DRAFT Proposal for Supplement 2 to UN Regulation No. 151 (Blind Spot Information Systems (BSIS))

The text reproduced below was prepared by the experts from the European Commission and OICA to modify the scope of the Regulation along with appropriate requirements. The informal document is based on ECE/TRANS/GRSG/2020/7. The modifications to the current text of the UN Regulations are marked in bold for new or strikethrough for deleted characters. The modifications to the document GRSG/2020/7 are marked in yellow.

M2/N2 vehicle trajectory on 2 lanes per road entering 1 lane road

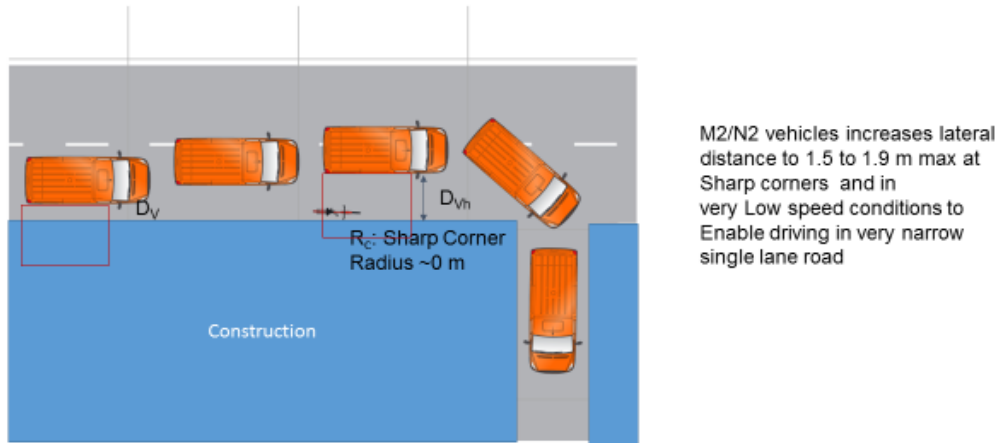
- (1) Paragraph 5.3.1 : The vehicle trajectory for smaller N₂/M₂ is not using a further left turn than 2 m, therefore with the 3 m coverage the cyclists remains covers.
